**STATE SIGNIFICANT DEVELOPMENT
ASSESSMENT REPORT:
Health Precinct Stage 1 Development,
Sydney University
(SSD 7974)**

Environmental Assessment Report
Section 4.40 of the *Environmental Planning and
Assessment Act 1979*

June 2018

Figure 10: Northern elevation (CIP envelope in green) (source: RtS Supplementary information)

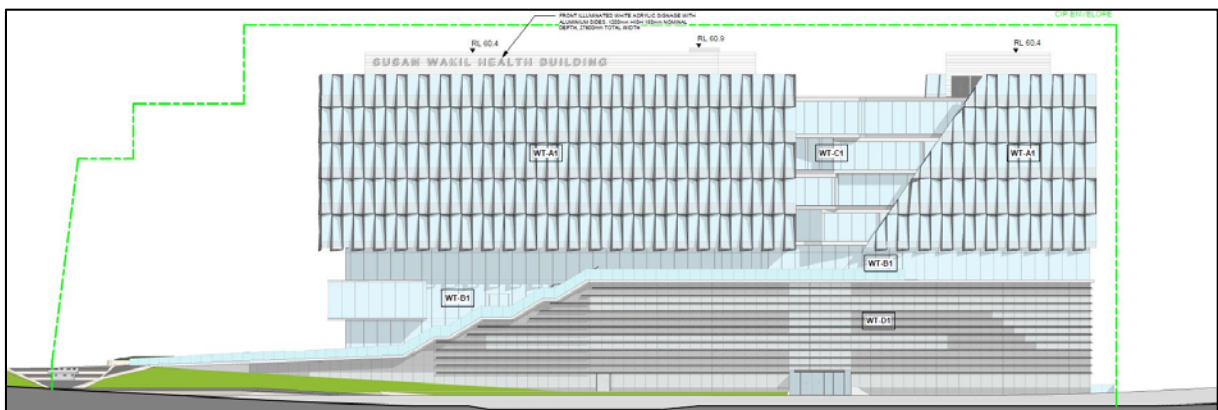
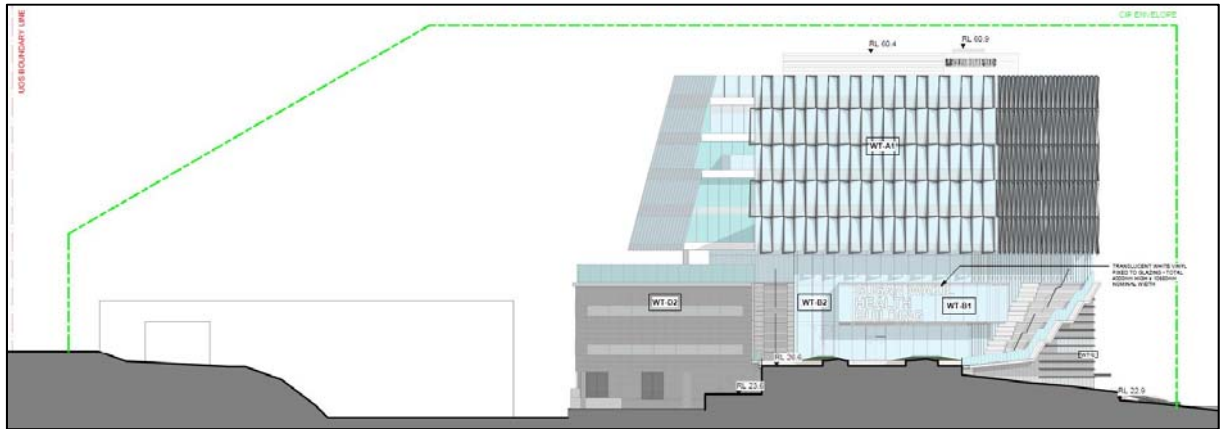
The proposal seeks approval for a new nine storey building, with a maximum building height 40.4 metres (RL 60.9) to the top of lift overrun (see **Figures 10 and 11**) and a maximum GFA of 21,198 sqm.

The Department has carefully considered the proposed building and considers the proposal is consistent with the approved CIP concept proposal. The proposed building is wholly contained within the extent of the CIP building envelope and utilises approximately 17.5 per cent of the total additional GFA assigned to the precinct.

Figure 14: Blackburn Circuit (source: RtS Supplementary information)

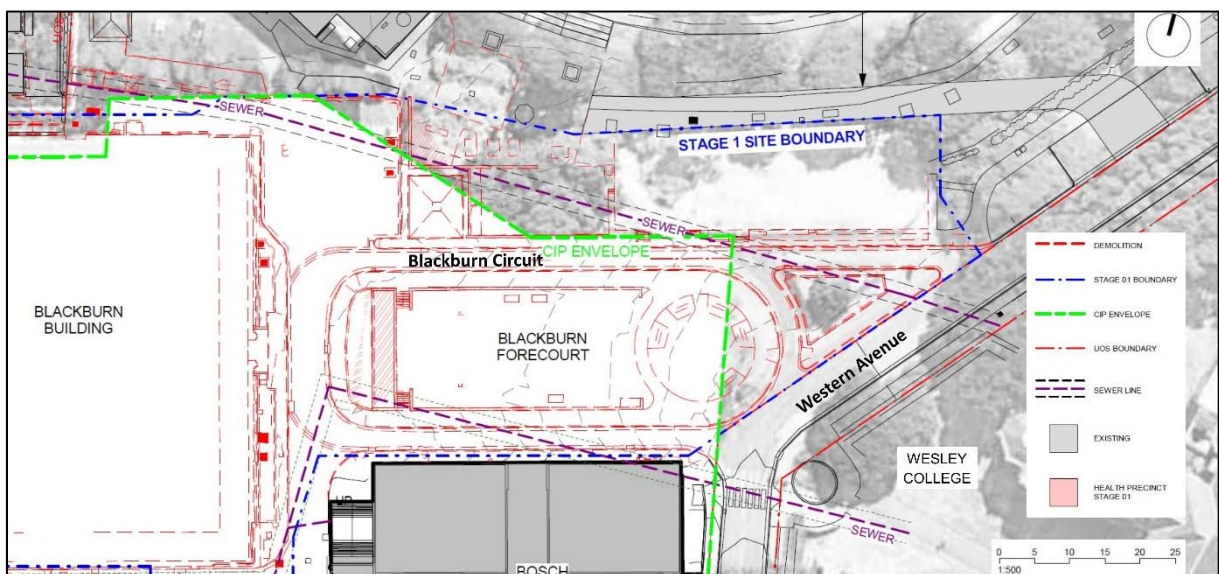
The proposal seeks to alter the vehicle access arrangements within the campus by removing the Blackburn Circuit (an internal road) and provide direct access from Western Avenue and a pick-up/drop-off facility on Western Avenue (see **Figures 14** and **15**). The proposal also includes a total of 26 new car parking spaces (with 23 located within the ground level of the proposed building). The ground level also includes a delivery bay for servicing and loading activities, accessed from Western Avenue.

TfNSW advised that the revised access arrangements would result in potential conflict between service vehicles and general traffic along Western Avenue, and would also create safety risks for pedestrians. It recommended a road safety audit (RSA) be prepared for the development.

Figure 16: Sensitive receivers (base source: NVA)

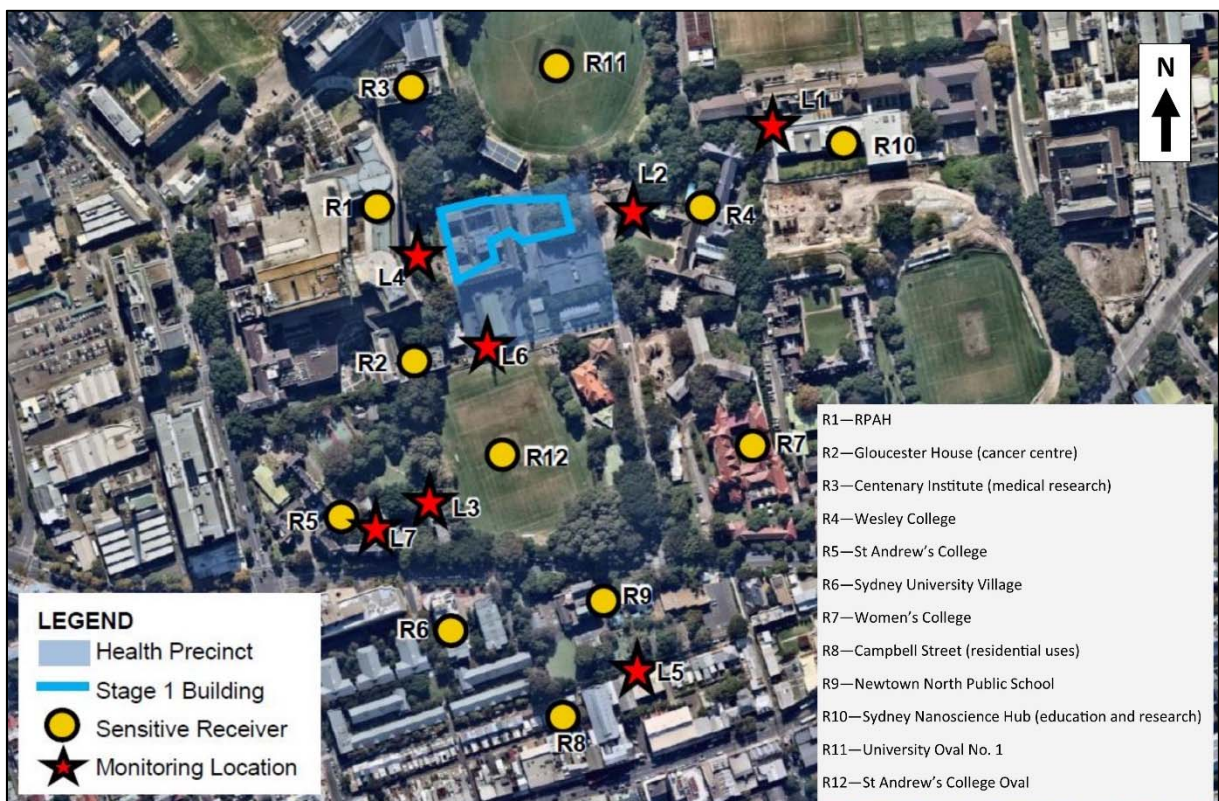
A revised Noise and Vibration Assessment (NVA) was submitted with the RtS that assessed the potential construction and operational noise and vibration impacts on nearby sensitive land receivers, including the adjoining RPAH, existing University educational establishments and residential colleges (see **Figure 16**).

The revised NVA was submitted to address the matters raised by the EPA, including recognising the need for ongoing consultation with the adjoining sensitive receivers during construction, establishing the rating background level (RBL) by undertaking background noise monitoring at the most sensitive receivers (RPAH and St Andrew’s College) in accordance with the *NSW Industrial Noise Policy (INP)* and further consideration of extended construction hours and associated construction noise and vibration impacts.
